1 ADDENDUM #4

- .1 The Tender Closing for Contract #1 Sitework & Foundation has been extended until December 02, 2021 @ 2:00PM local time.
- .2 Location of Tender Closing is Jones Building, 11 Kent Street, Charlottetown.

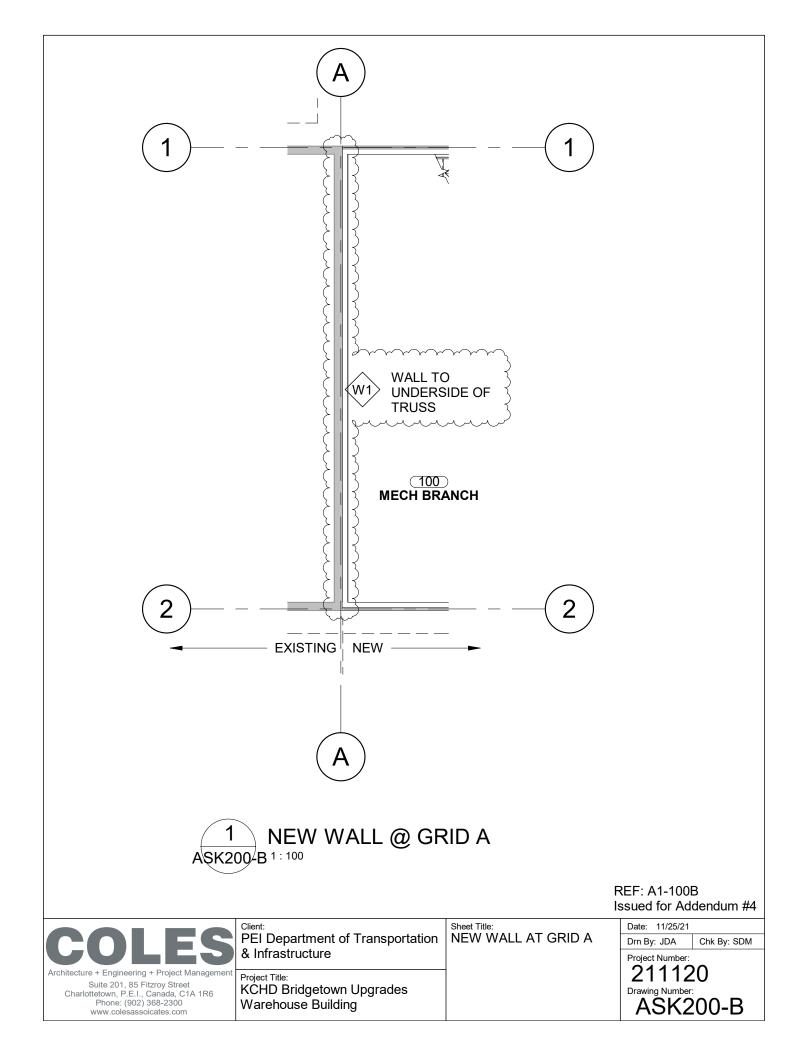
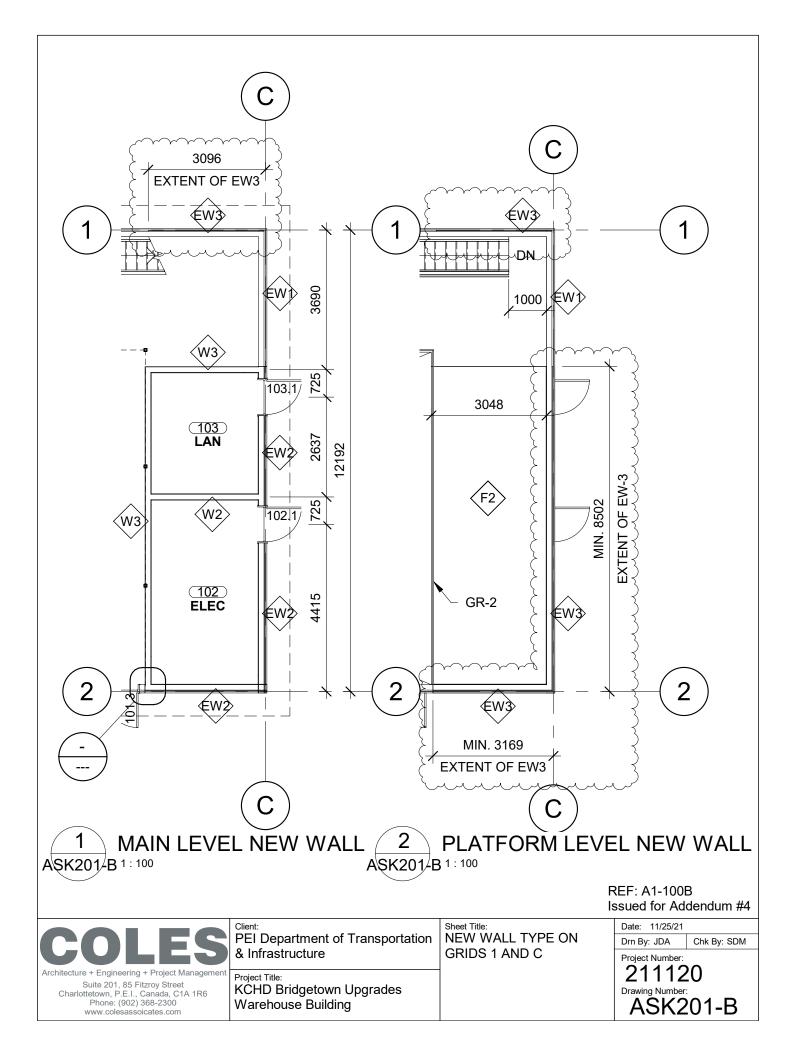
- .1 <u>Reference Drawing A1-003B Notes & Assemblies</u> .1 Refer to attached ASK202-B for the revised wall assemblies.
- .2 <u>Reference Drawing A1-100B Floor Plan</u> .1 Refer to attached ASK200-B and ASK201-B for the revised wall types and locations.
- .3 Reference Drawing C103 Details & Notes
 - .1 Provide six (6) bollards around the DEF building as per Detail 2/C103. Final location to be confirmed on site.

TYPE	NBCC	- DESCRIPTION	~~~~~~	FIRE RATING	STC	REMARKS
W1	N/A - 38mm x 140mm WOOD STUD FRAMING @ 400mm O.C. (VOID CAVITY) - 12mm PLYWOOD - PLYWOOD TO BE ON SIDE AS NOTED WITH WALL TAG			> N/A	N/A	
W2	NBC 2015, W1A	- 38mm x 140mm WOOD C/W MINERAL WOOD IN	BOARD TYPE X (1 LAYER) STUD FRAMING @ 400mm O.C. ISULATION (FILL CAVITY) BOARD TYPE X (1 LAYER)	1 HOUR	36	
W3	NBC 2015, W1A	- CONTINUOUS AIR BAF - 38mm x 140mm WOOD C/W MINERAL WOOL IN - 6MIL POLY VAPOUR B - 16mm GYPSUM WALL	STUD FRAMING @ 400mm O.C. SULATION (FILL CAVITY)	1 HOUR	36	
EXTERIO	R WALL SCHEI	DULE R1				
TYPE	DESCRIPTION			REMARKS		
EW1	 METAL CLADDING VERTICAL (EXPOSED FASTENERS). CP-1. CONTINUOUS AIR BARRIER (STAPLED) 38mm x 89mm WOOD PURLINS @ 610mm O.C. 38mm x 140mm WOOD STUD FRAMING @ 400mm O.C 					
EW2	- METAL CLADDIN - 19mm x 89mm W - CONTINUOUS A - 19mm EXTERION - 38mm x 140mm V	NG VERTICAL (EXPOSED /OOD STRAPPING @ 400r /IR BARRIER (STAPLED) R PLYWOOD SHEATHING WOOD STUD FRAMING @
